**TOWN OF MOUNTAIN VILLAGE
REGULAR DESIGN REVIEW BOARD MEETING
AGENDA
THURSDAY MARCH 3, 2022 10:00 AM
MOUNTAIN VILLAGE TOWN HALL
455 MOUNTAIN VILLAGE BLVD, MOUNTAIN VILLAGE, COLORADO**

4.	10:35	45	Ward/Applicant	Quasi-Judicial	Consideration of a Design Review: Initial Architecture and Site Review for a new Single Family home on Lot 344R, 111 Rocky Rd., pursuant to CDC Section 17.4.11.

TO: Mountain Village Town Council
FROM: Amy Ward, Senior Planner
FOR: Design Review Board Public Hearing; March 3, 2022
DATE: February 23, 2022
RE: Staff Memo – Initial Architecture Review (IASR) Lot 344R, 111 Rocky Road

site plan

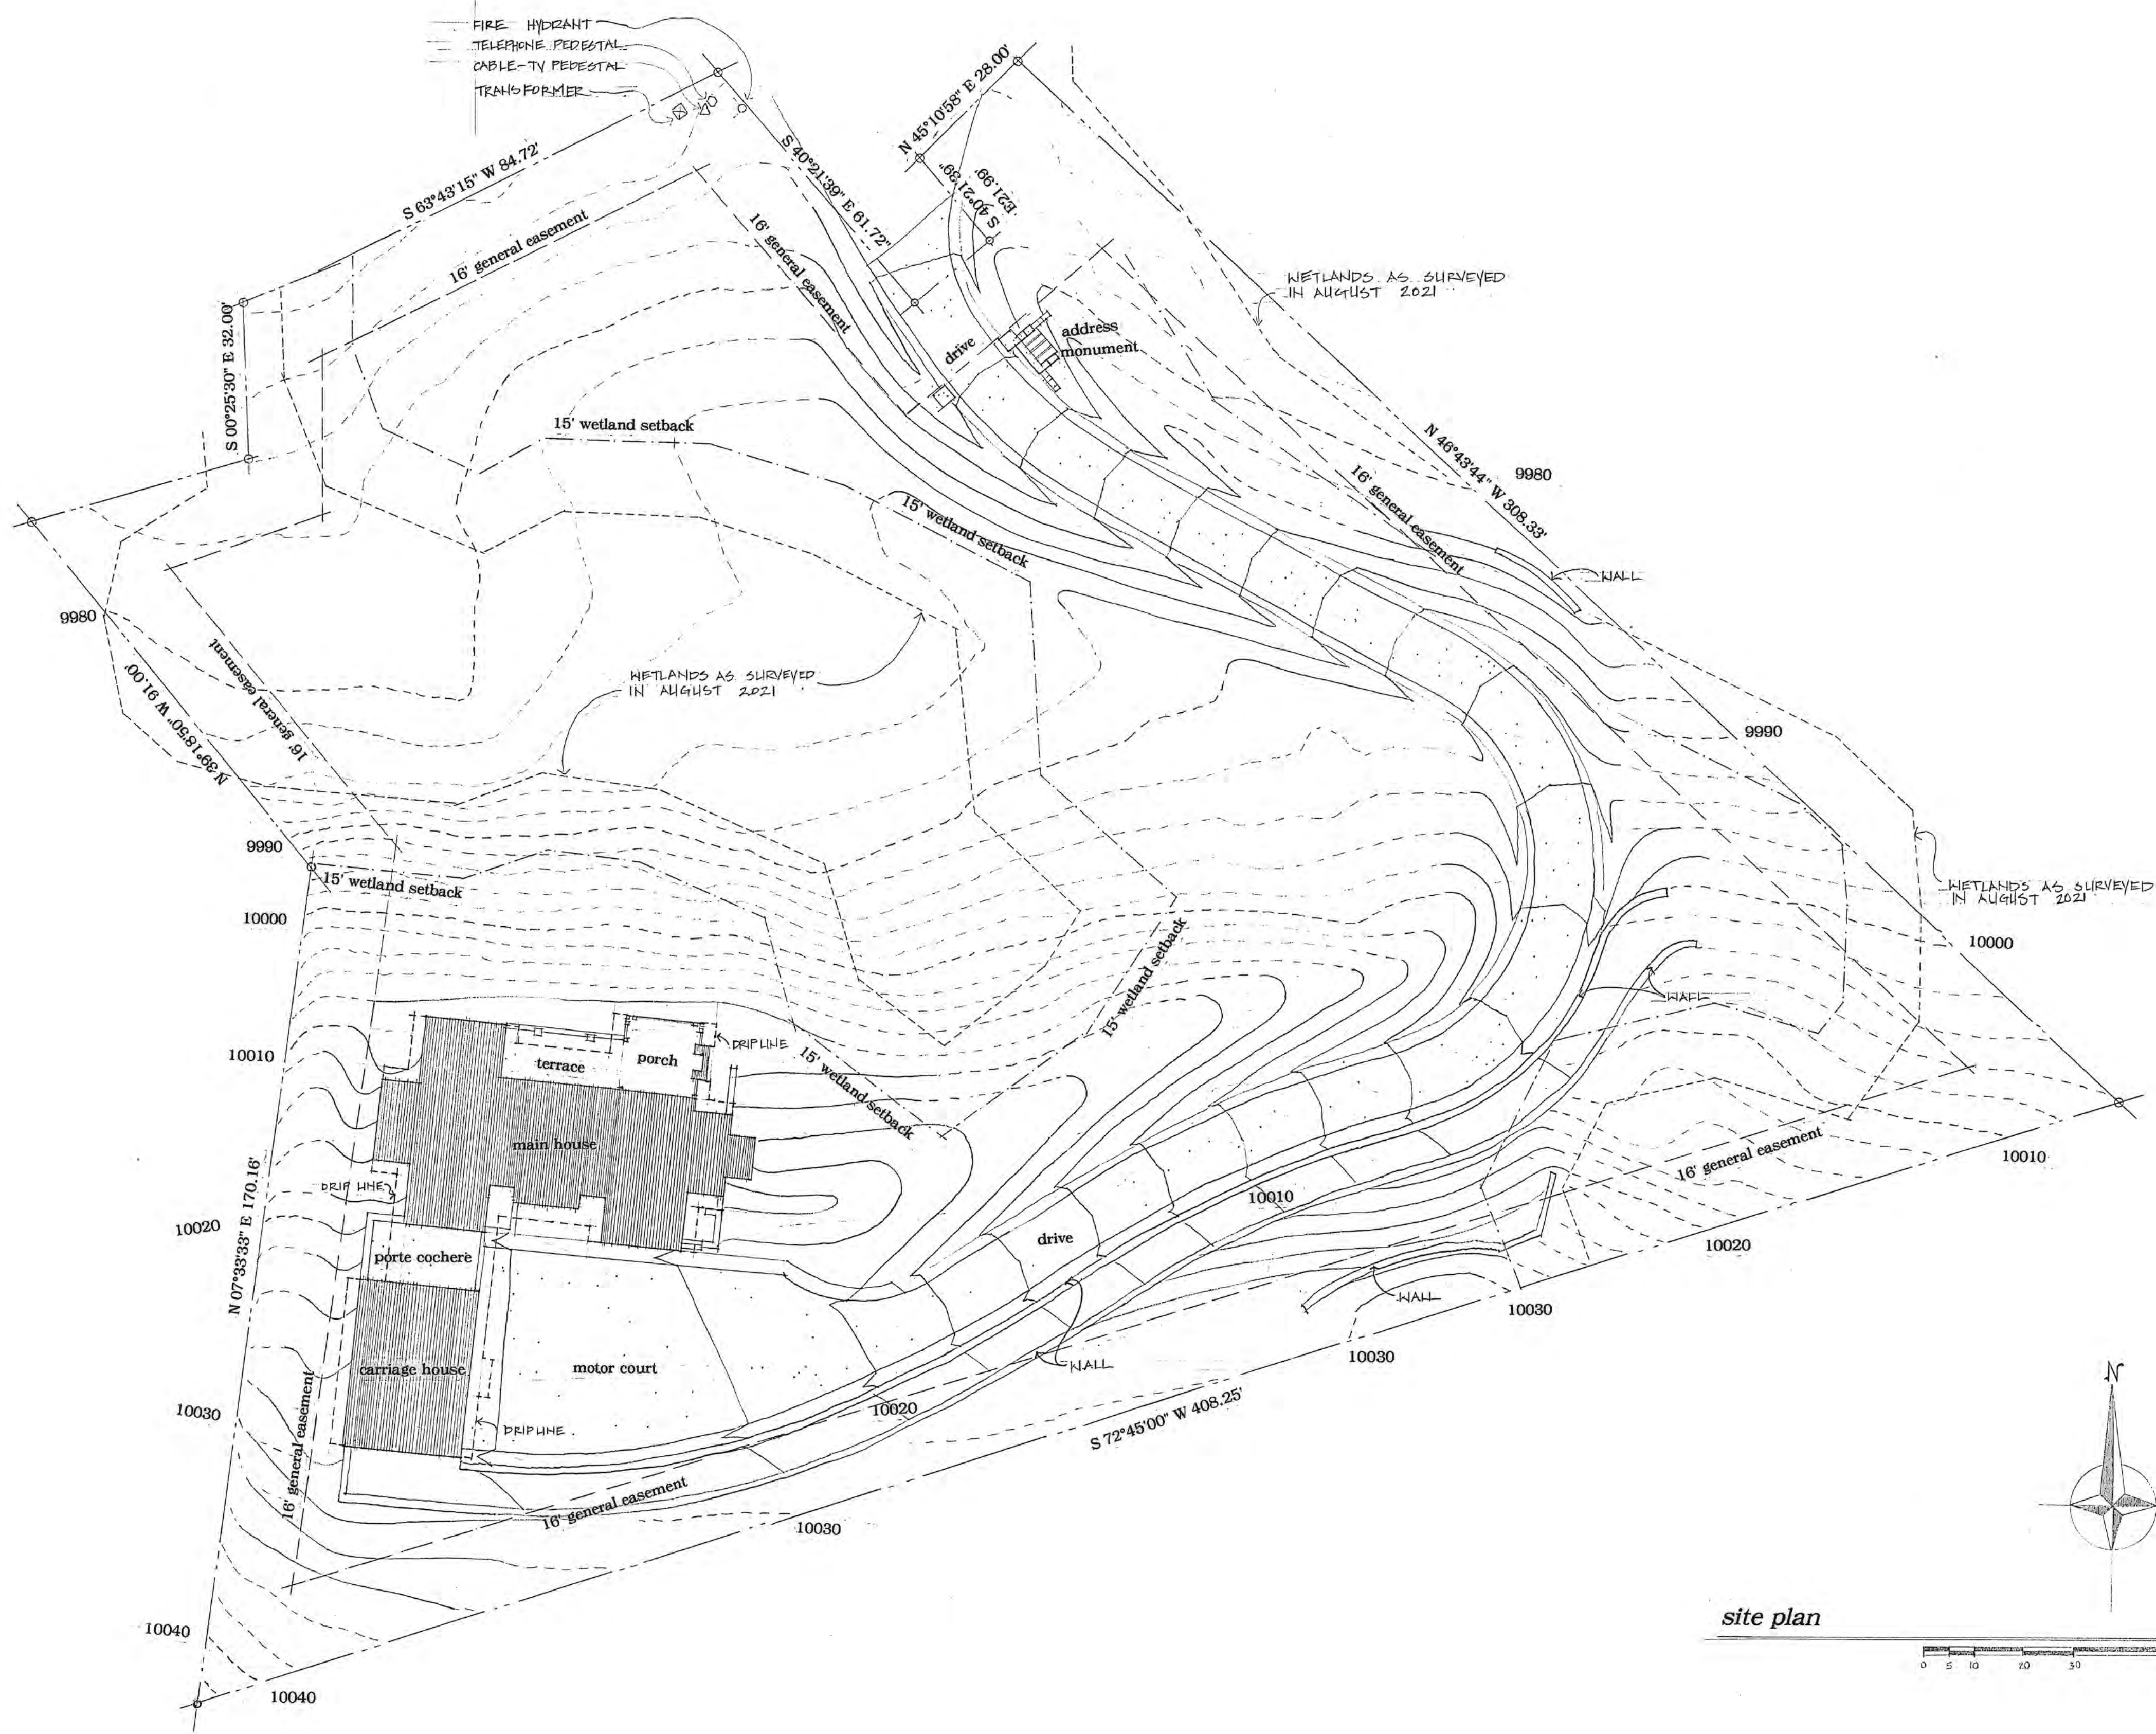
Staff: The applicant has shown two interior parking spaces on their plan. They have indicated one exterior parking space in their summary, however it is not shown on the plans. They are required to show (2) exterior parking spaces. This should be amended prior to final review.

AVERAGE BUILDING HEIGHT : 16'-7 1/4"
GLAZING PERCENTAGE : 15%
STONE PERCENTAGE : 51%
MAXIMUM BUILDING HEIGHT : 33'-9"

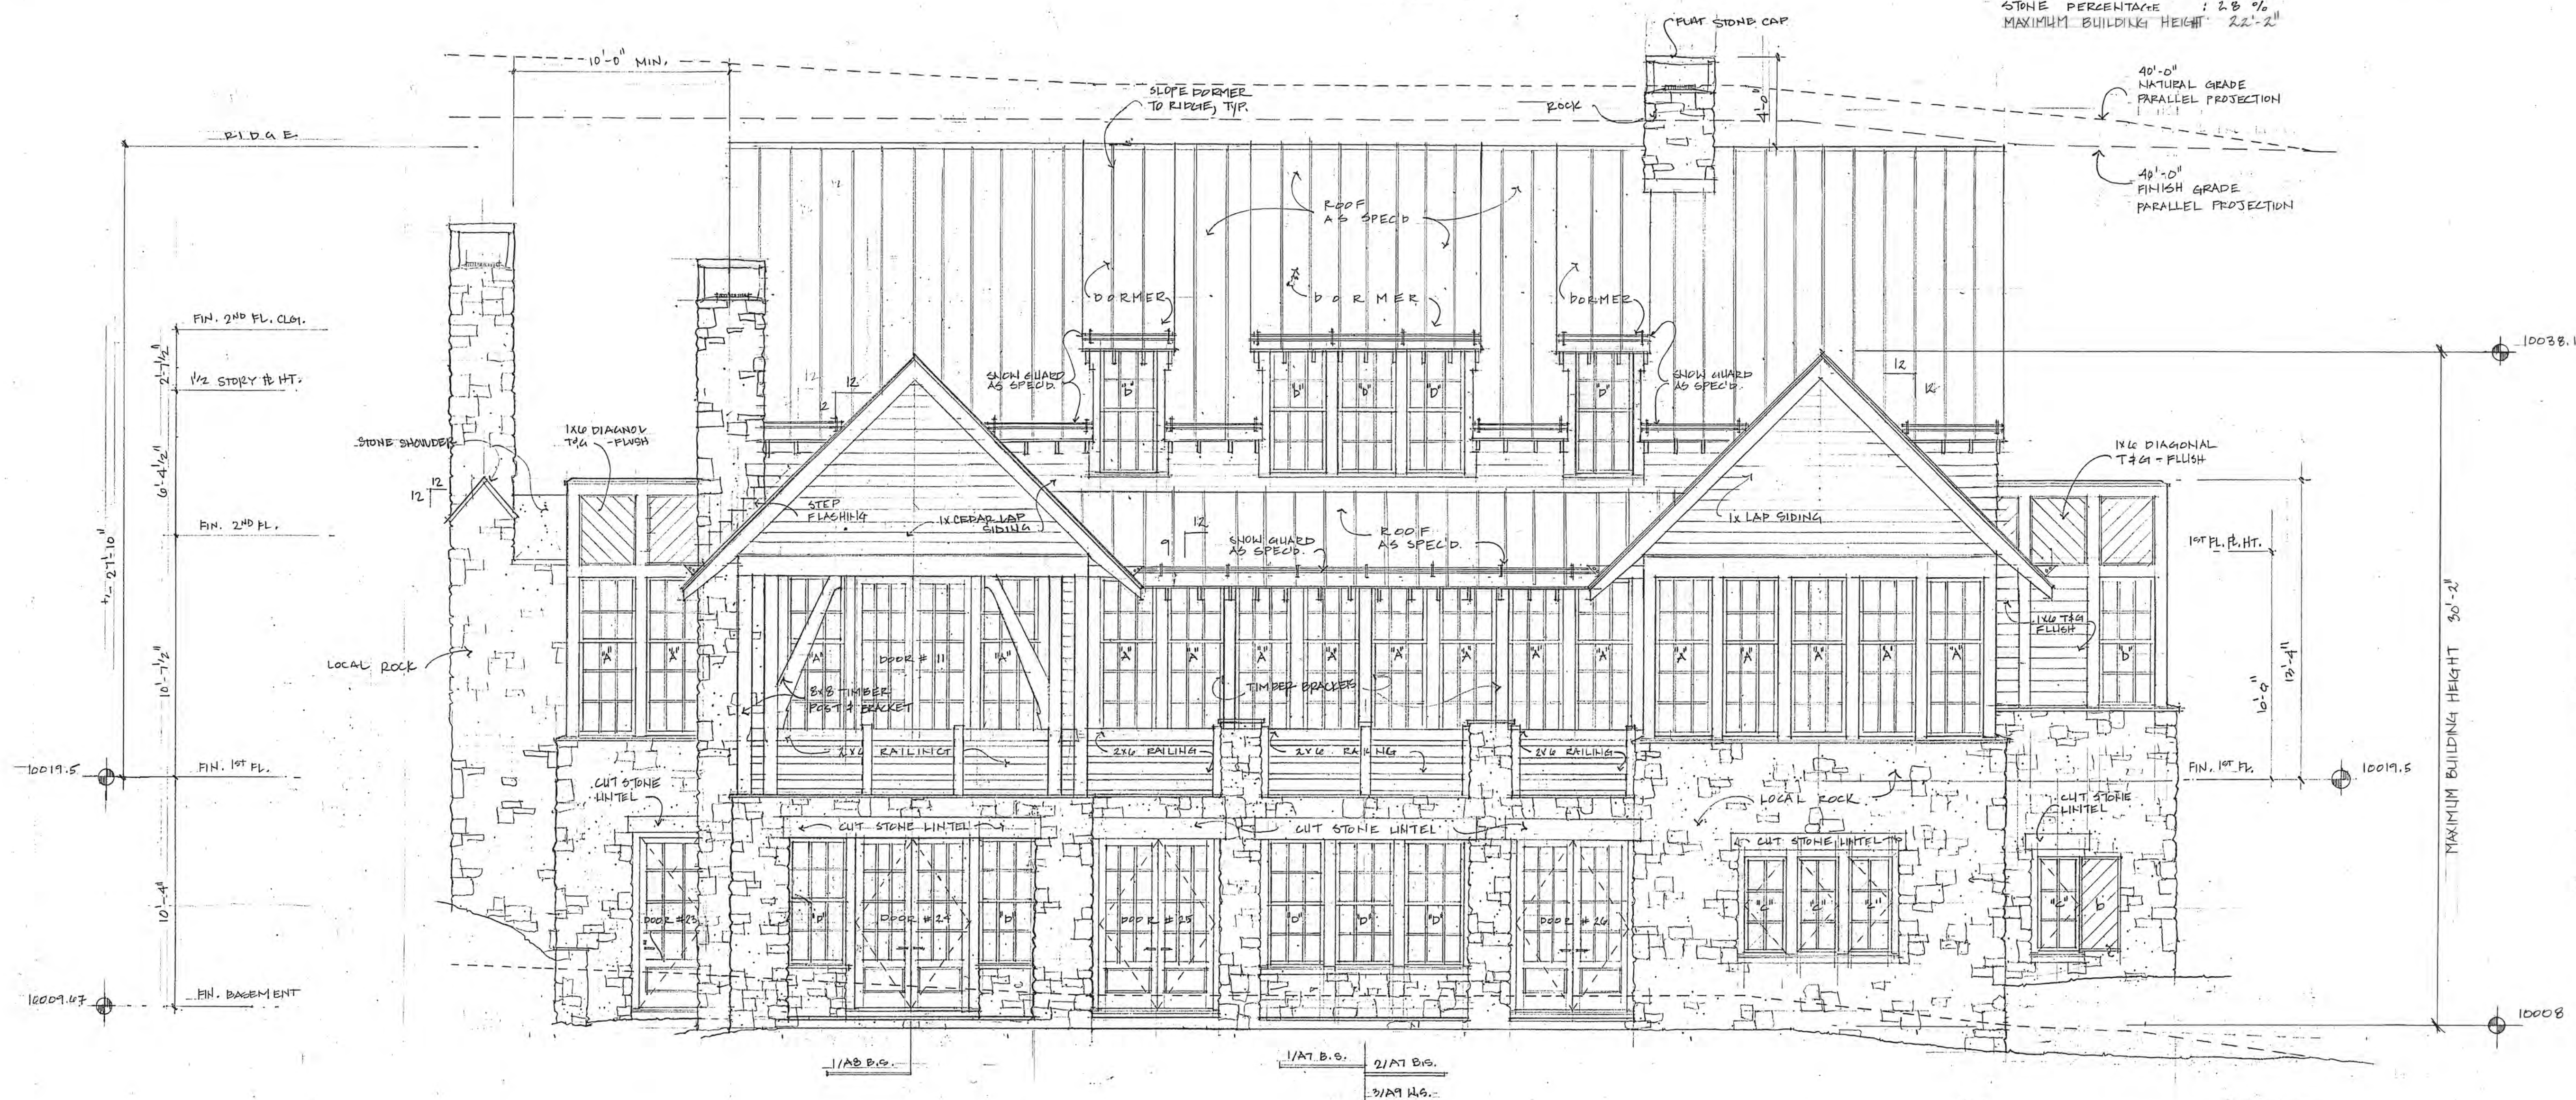
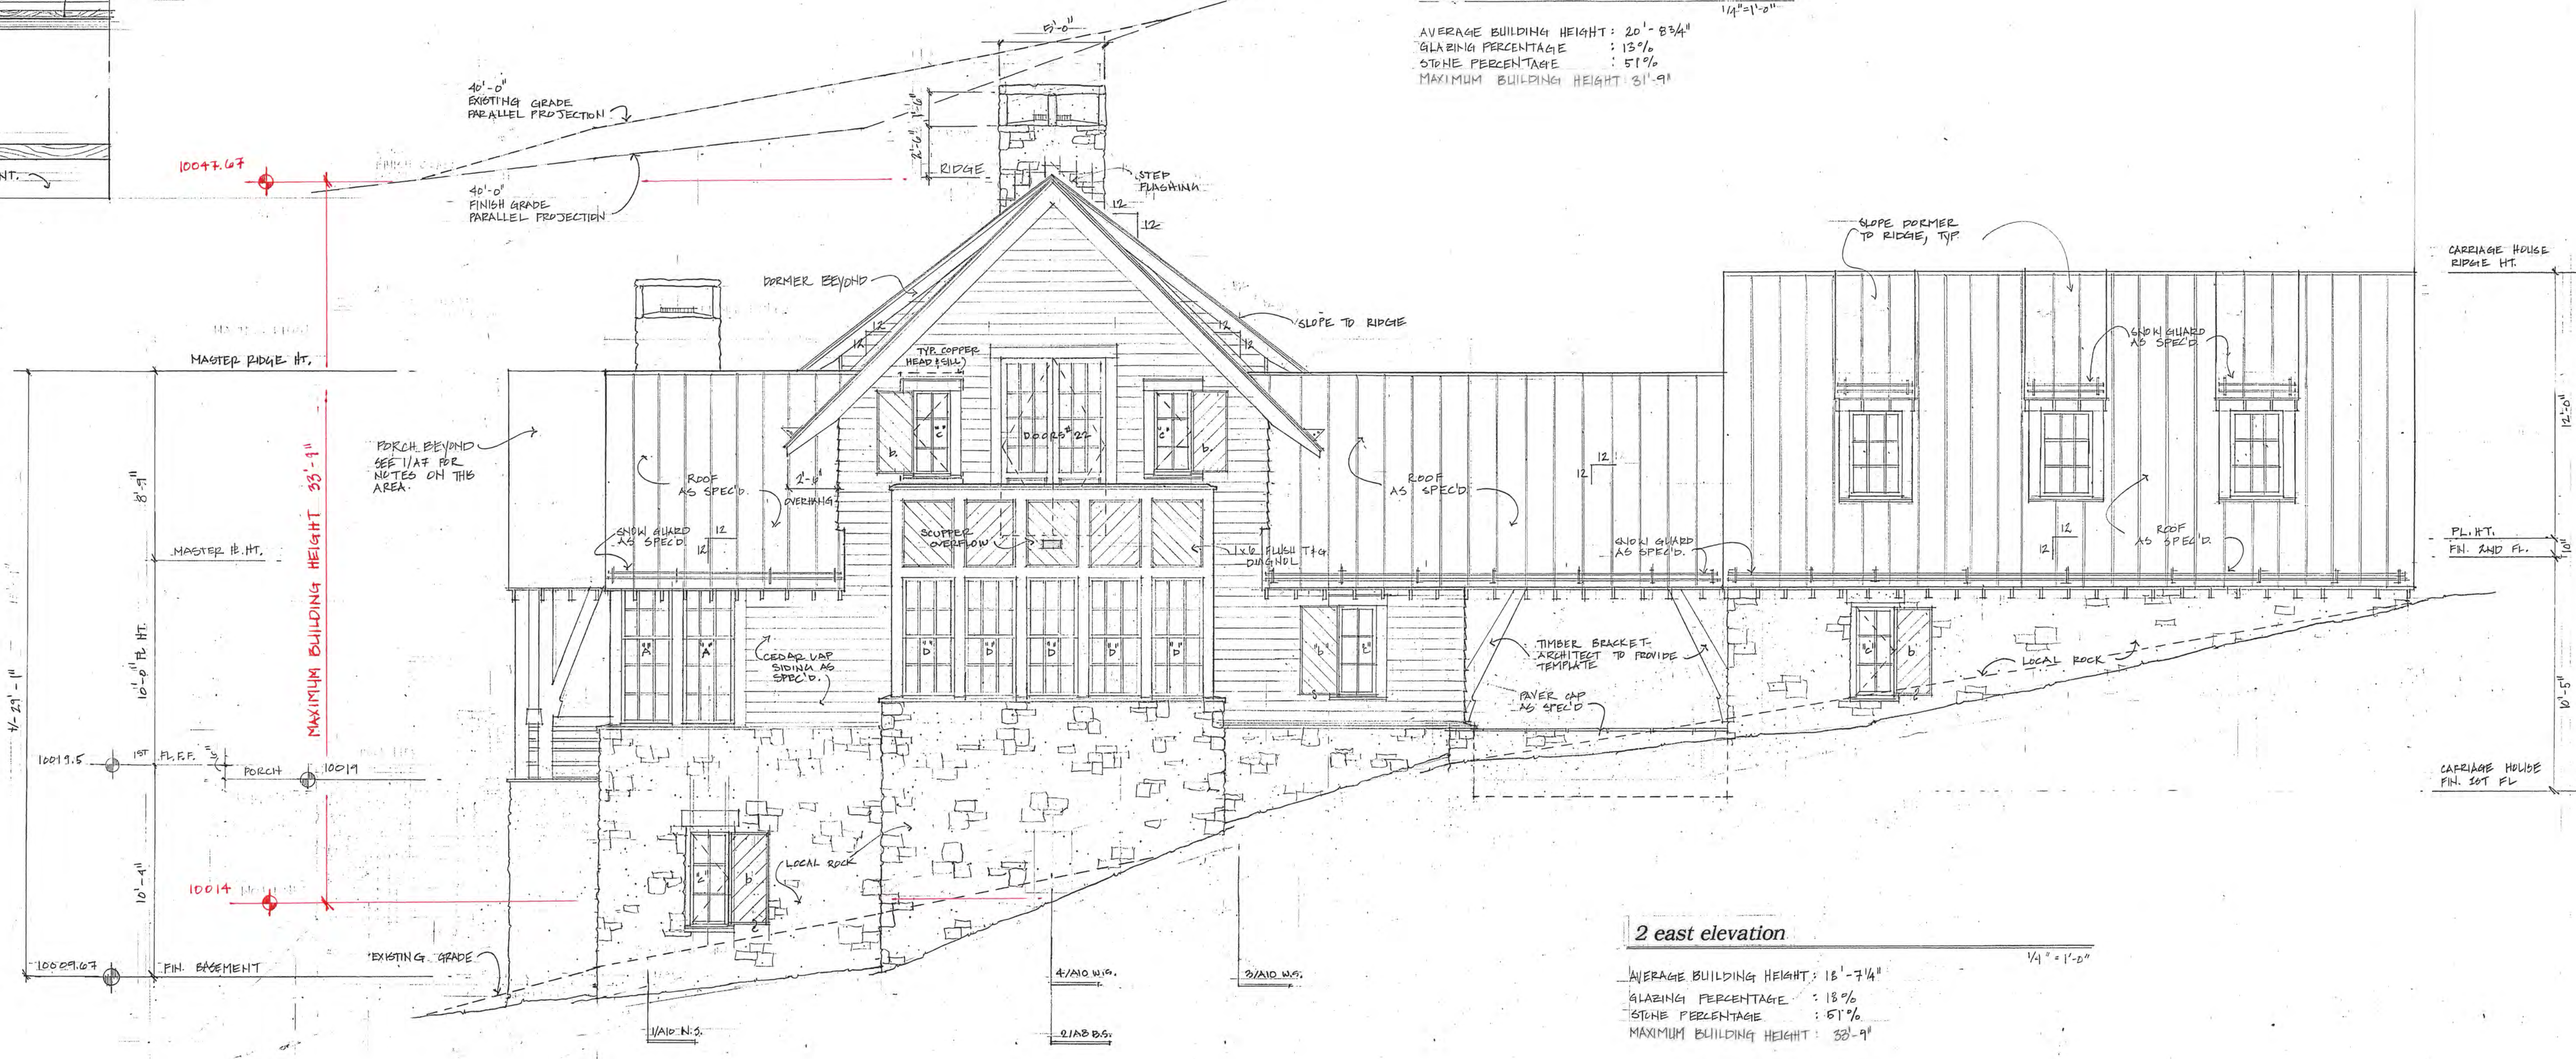
Staff: Staff has determined that the primary roof form for this home is a gable and therefore granted a maximum height of 40 feet. The applicant has calculated a max height of 33' 9" and a max average height of 24' 6". The home appears to meet the requirements for both max and max average height. The plan set demonstrates height compliance with a parallel plane analysis that shows both existing and proposed grade.
